**STAFF REPORT 10-14-2020 REGULAR MEETING**

**APPLICATION NUMBER: 20-6886**

**ADDRESS: 515 PARKVIEW DRIVE**

**SCOPE: REPLACE THE EXISTING FRONT PORCH WITH A NEW FRONT PORCH**

SHEET NO.  
**A-1**  
 OF 1

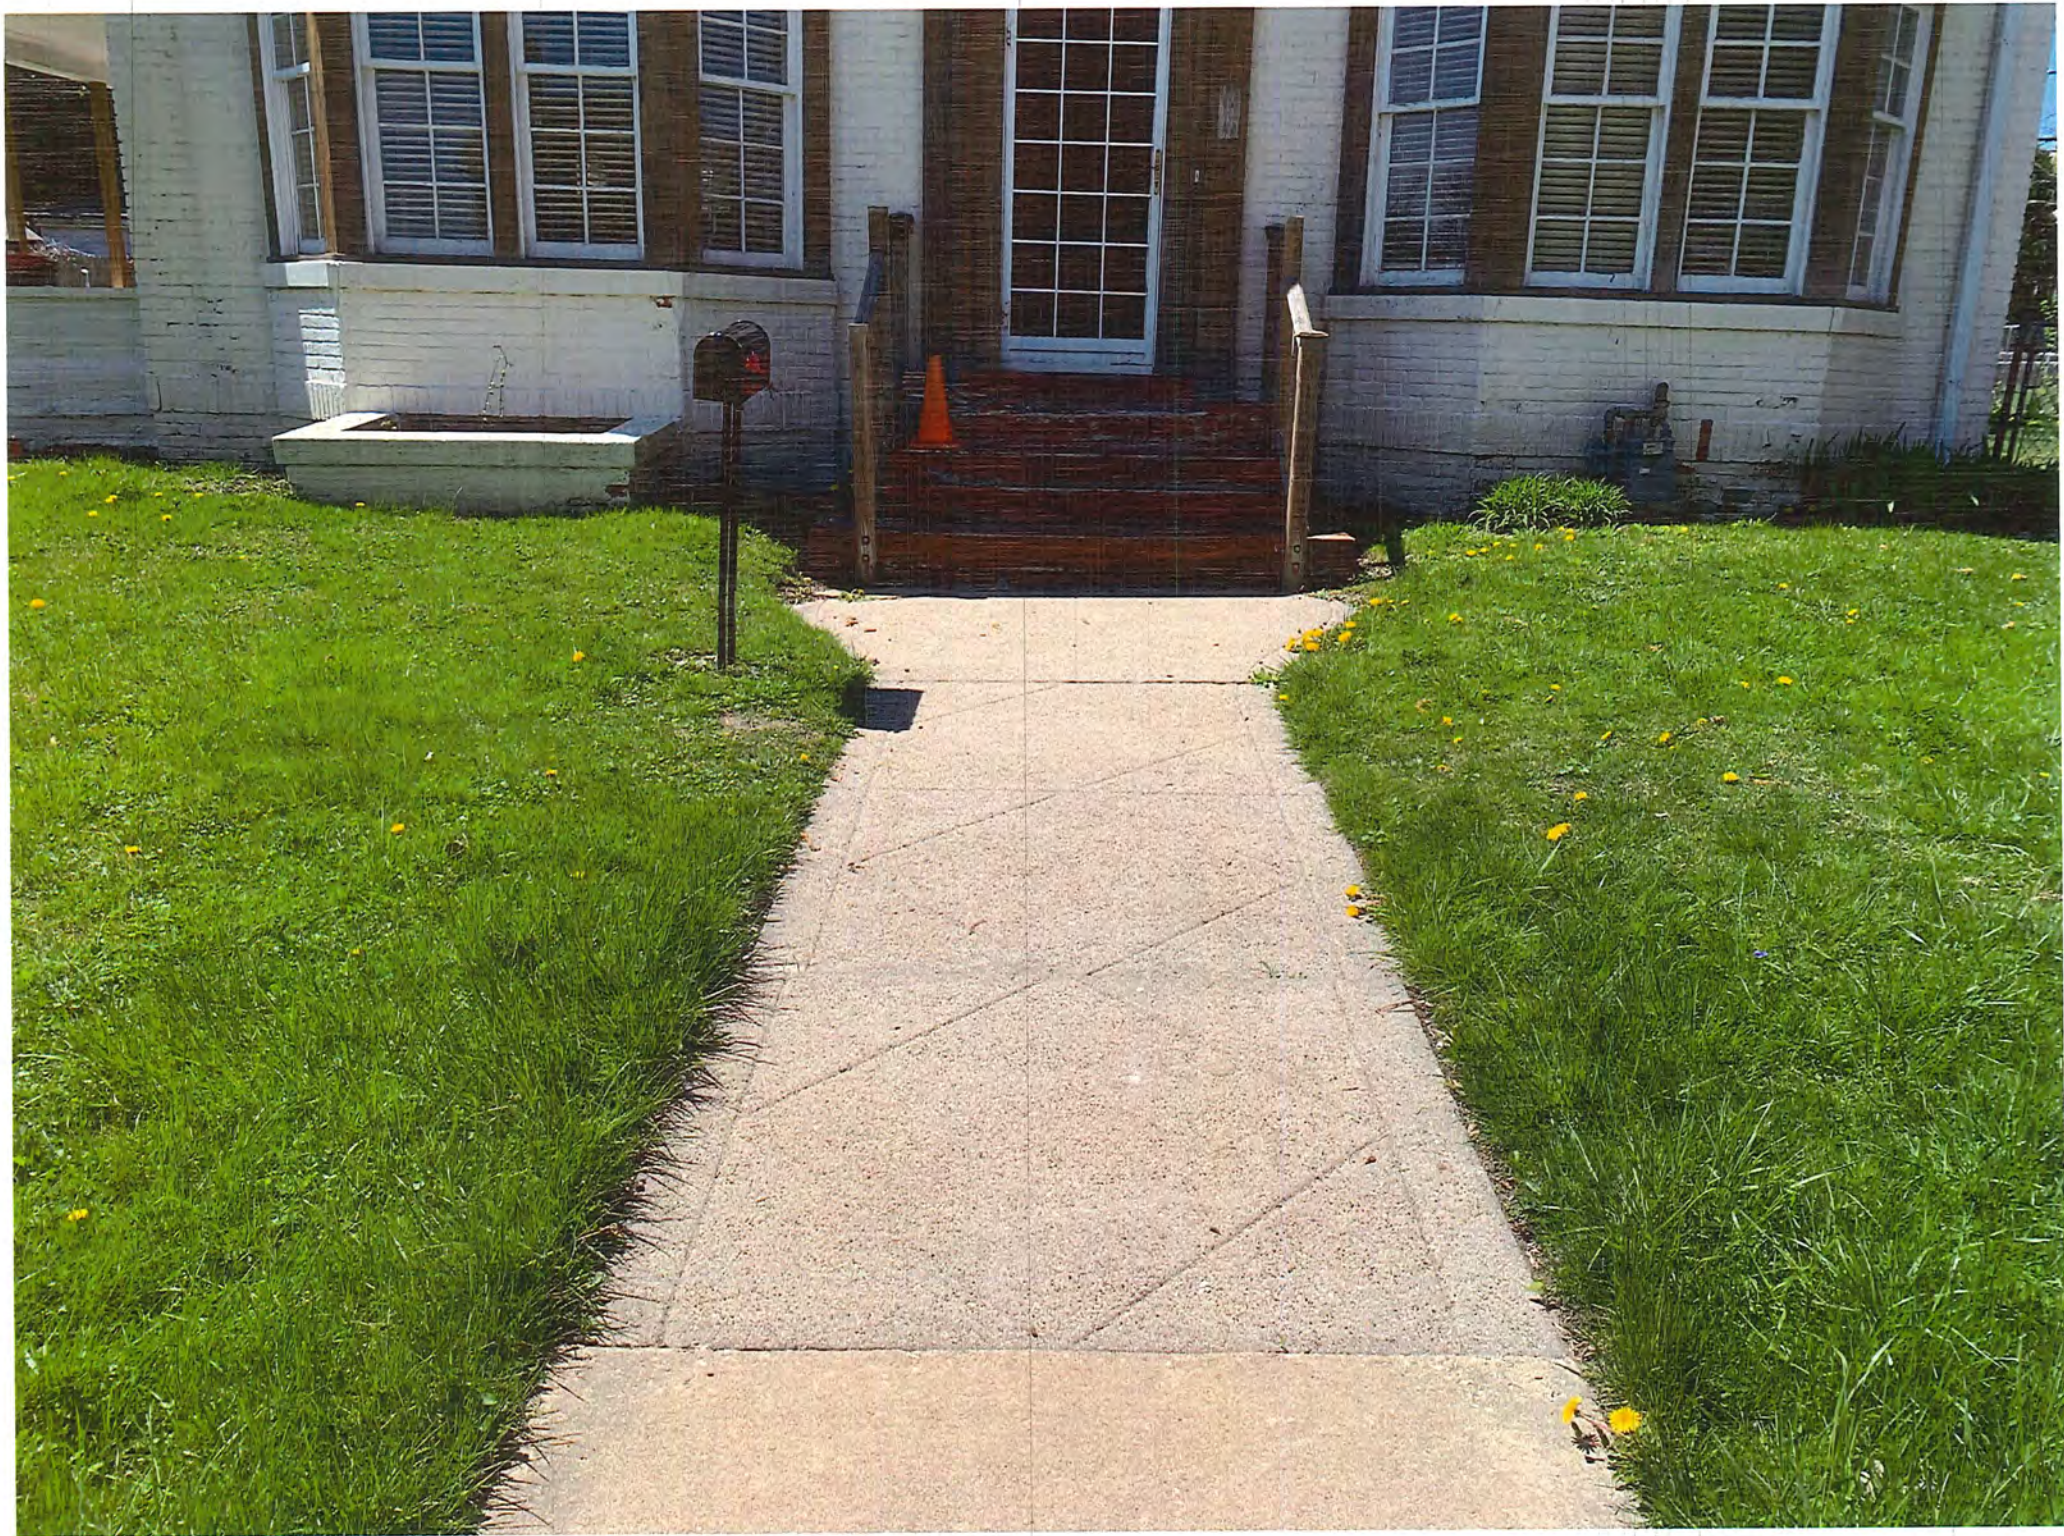
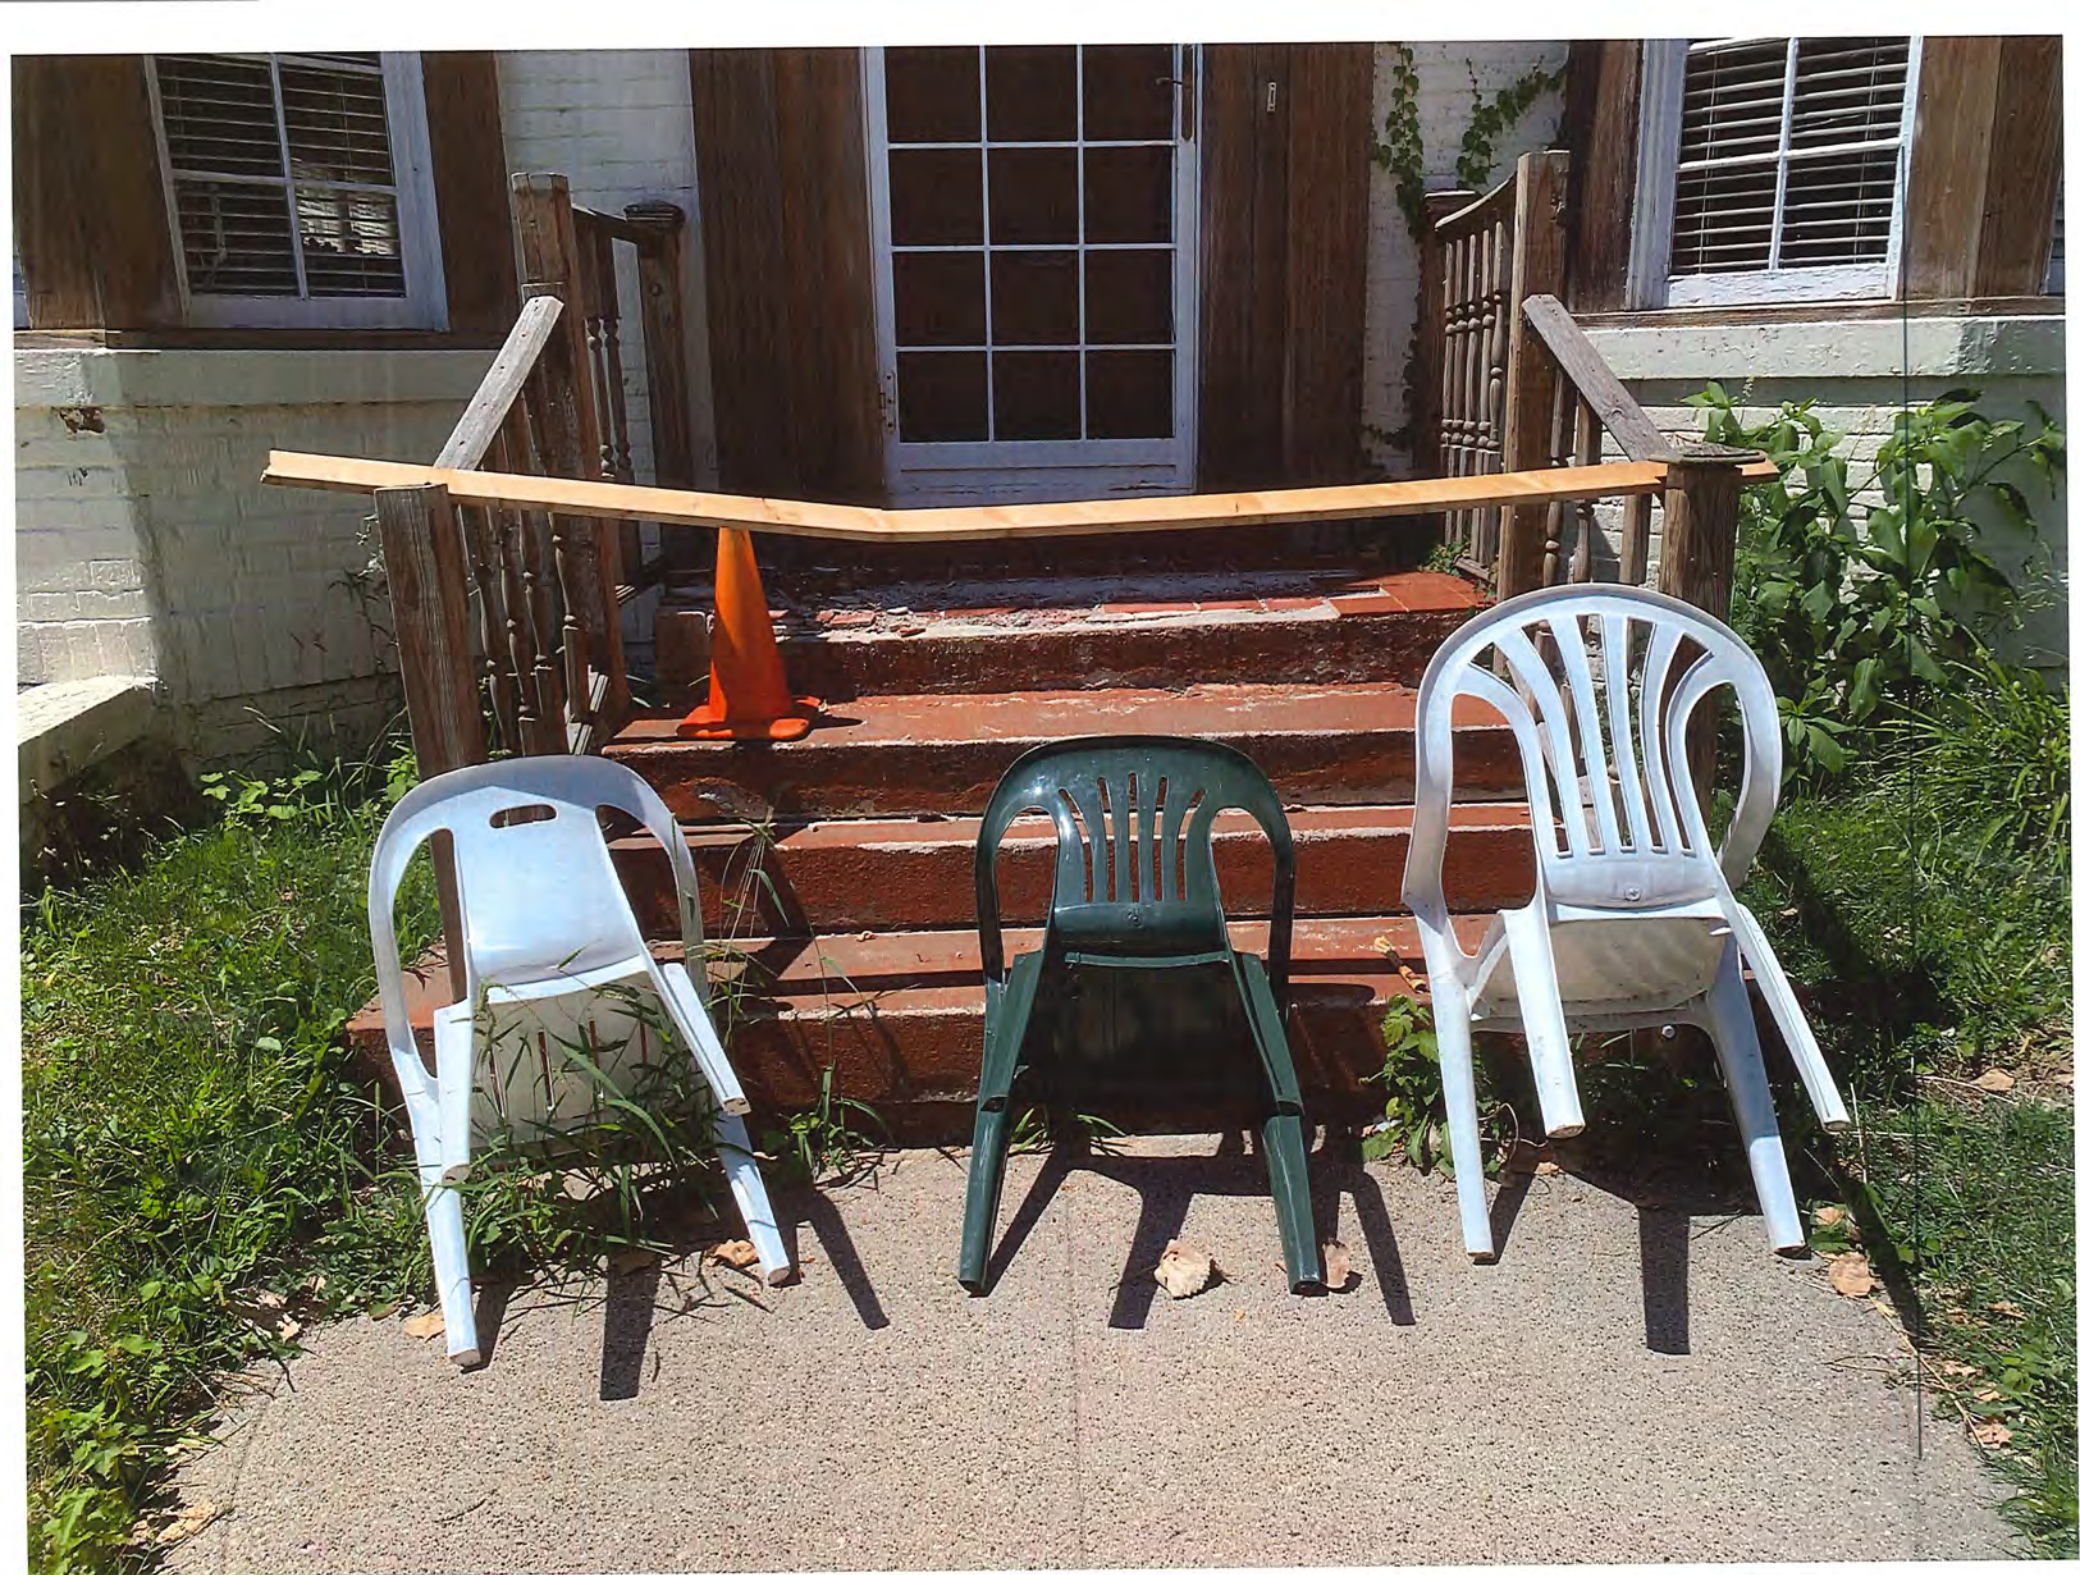
- There is a discrepancy in the documented dimensions of the existing front porch between the previous submission and the current submission. The previous submission documents the existing porch as 8'W x 3'D while the current drawings document the existing porch as 7'0"W x 3'-6"D. The applicant has confirmed that the correct dimensions of the existing porch are 8'W x 3'D.

- The deck of the reconstructed porch must be 8'W x 3'D in size to match the size of the deck of the existing porch.
  - The applicant shall revise the submission to reflect the updated railing and submit to HDC staff for review and approval prior to pulling the building permit for the project.
